Type Coffee Vending Machine	Model C2100 – C3100	T.I. NO 10 - 2016
Serial Number 63911589	Subject NEW BOILER COVER ASSEMBLY	ISSUED FOR (X) Action Information X

TECHNICAL INFORMATION JDE

New Boiler cover Assembly

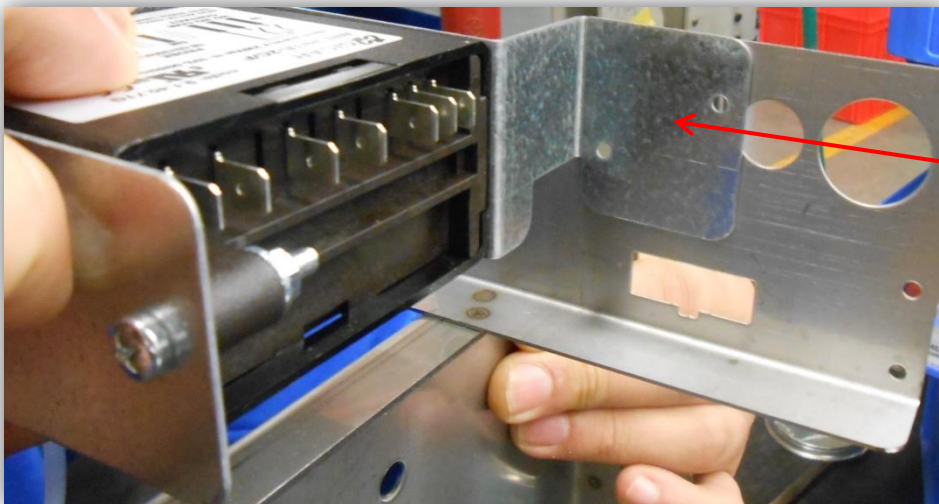
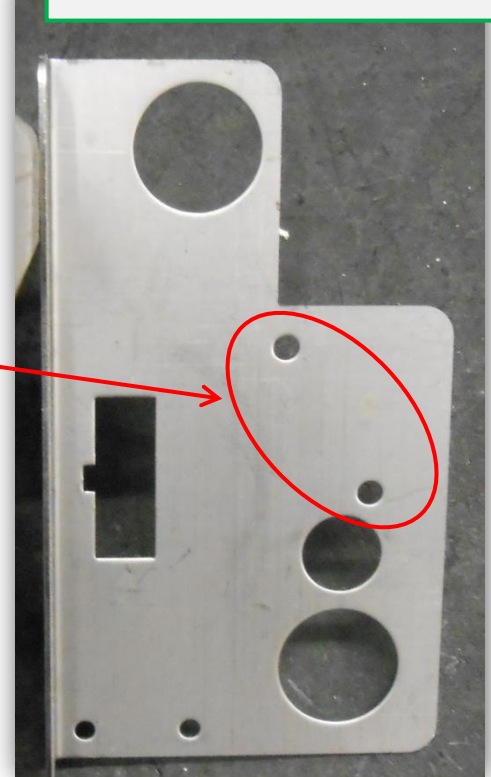
It's required to create the **support** fixing points to improve the fixing of the *electronic board*

Two holes have been added in the *Boiler solenoid valve support*. They are used to fix the **electronic control board** showed below.

For the machines prior to the above mentioned serial number it's possible to implement the new *Boiler cover Assembly*.
